16830 W. Devonshire St
LADOT Case No. SFV21-111453
LADOT Project ID No. 51682

Subject: **TRANSPORTATION IMPACT ASSESSMENT FOR THE PROPOSED HOME DEPOT DEVELOPMENT LOCATED AT 16830 WEST DEVONSHIRE STREET (CPC-2022-1981-CU-SPP-SPR/ENV-2022-1982-EAF)**

Figure 2-3
Site Plan

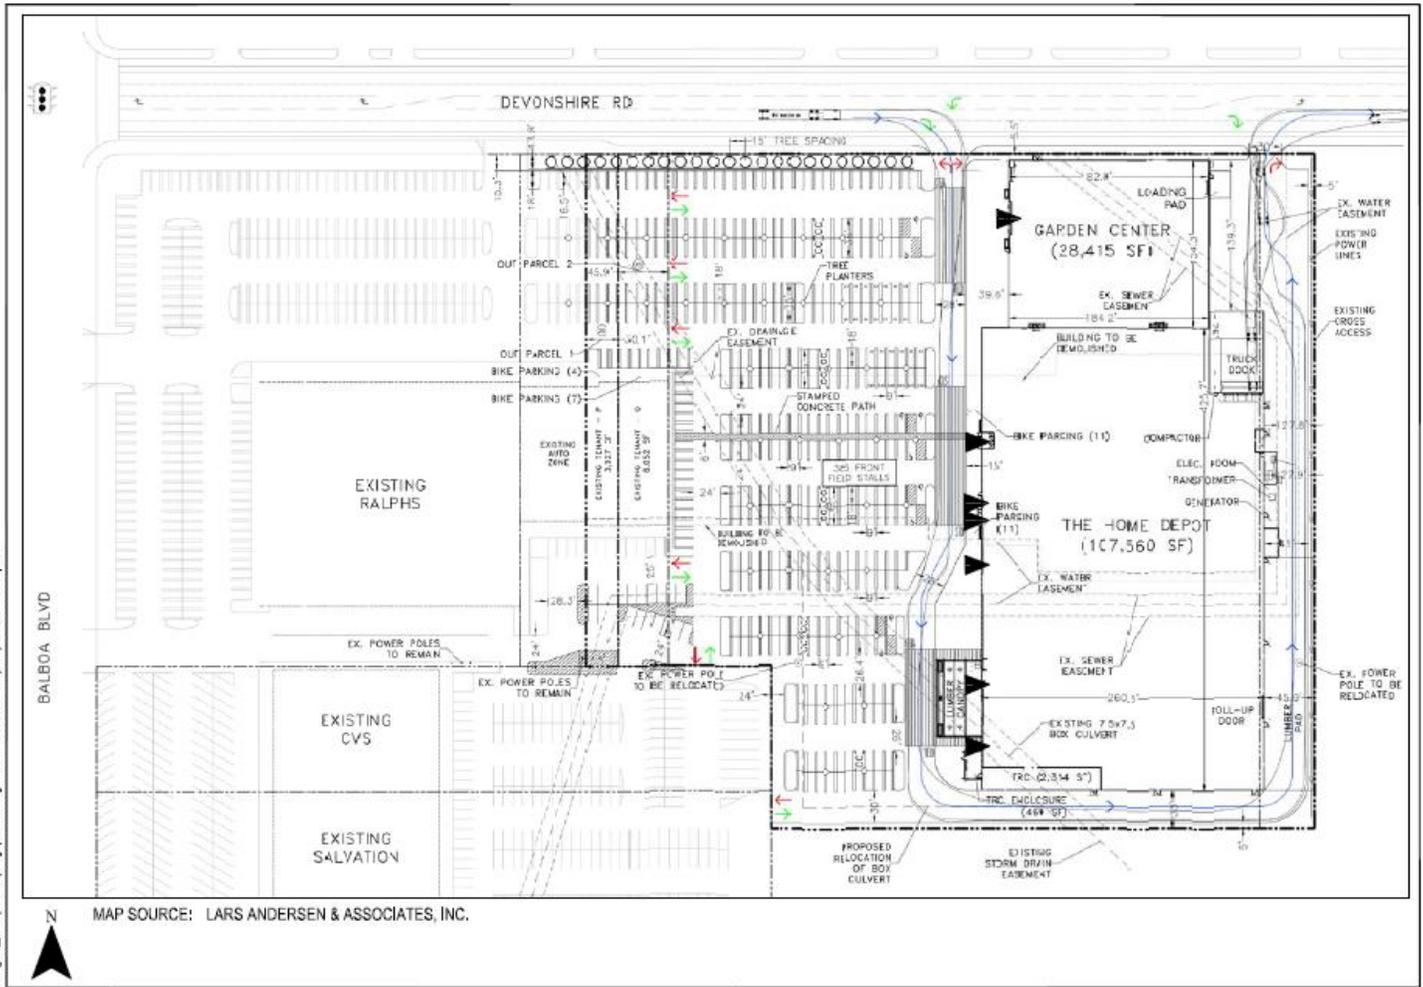
Main vehicular access to the project site is currently provided via the two existing site driveways on Devonshire Street (i.e., along the northerly property frontage). Secondary access to the project site is currently provided via a third existing westerly shared access driveway on Devonshire Street. The Existing Devonshire Street Middle Project Driveway will provide access to the main internal drive aisle located in the front of the proposed building. The driveway will continue to accommodate full access (i.e., left-turn and right-turn ingress and egress traffic movements). Westbound left-turn movements at this project driveway will be accommodated via the existing two-way left-turn lane on Devonshire Street. The Existing Devonshire Street Easterly Project Driveway will be limited to right-turn ingress and egress traffic movements only due to the existing eastbound left-turn lane on Devonshire Street at Petit Avenue. The site driveway will provide access to the truck dock and loading pad proposed for the project. The Existing Devonshire Street Westerly Project Driveway currently serves the existing North Hills Shopping Center and would also serve as secondary access to the proposed project. The driveway will continue to accommodate full access. Additional vehicular access to the project site will be provided via the three existing shared access driveways on Balboa Boulevard south of Devonshire Street for the North Hills Shopping Center. A shared driveway is also provided with the adjacent parcel to the east (i.e., Citibank site). A copy of the project site plan is shown in **Attachment C**.

The review of this study does not constitute approval of the existing driveway dimensions, access, and circulation scheme with regard to this project. Those elements require separate review and approval and should be coordinated with LADOT's Valley Planning Coordination Section (6262 Van Nuys Boulevard, Rm 320, @ 818-374-4699). To minimize and prevent last-minute design changes, the applicant should contact LADOT before the commencement of building or parking layout design efforts, for driveway width and internal circulation requirements. New driveways should be Case-2, designed with a recommended width of 28 feet for two-way operations, or 16 feet for one-way operations, or to the satisfaction of LADOT. Additionally, the applicant should check with City Planning regarding the project's vehicular access and design.
